18-074ARB-MPR – SCHMITT RESIDENCE

Proposal

Construction of a 720-square-foot building addition, covered porch, exterior modifications, and associated site improvements.

18-074ARB-MPR
Minor Project Review
109 S. Riverview Addition

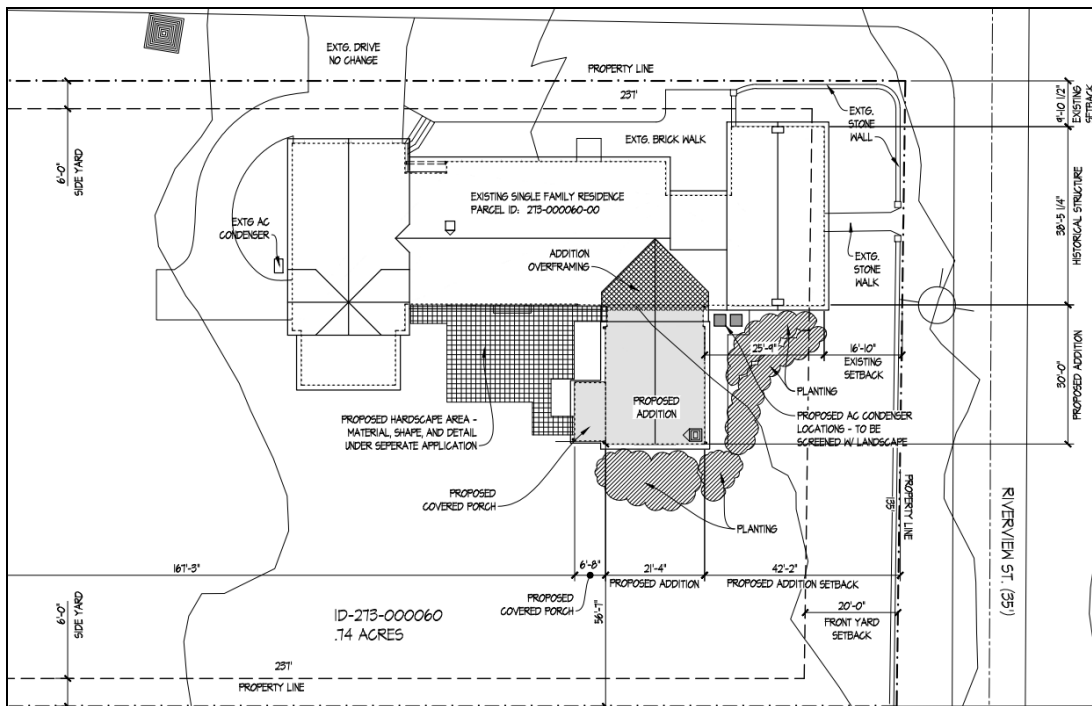
The applicant is proposing a chimney along the S. Riverview Street elevation. Staff and ART raised concerns that the size of the chimney is not compatible with the chimneys on the historic structure and the previous additions. The applicant has indicated the dimensions of the chimney are limited by Building Code requirements. Staff recommends the applicant investigate a design solution to reduce the size of the proposed chimney.

- 1) That the applicant reduce the size and scale of the chimney on the proposed addition; and,
- 2) That the final details associated with the at-grade patio be approvable by Planning through issuance of a Certificate of Zoning Plan Approval provided the design be deemed appropriate, and the general size and location do not change.
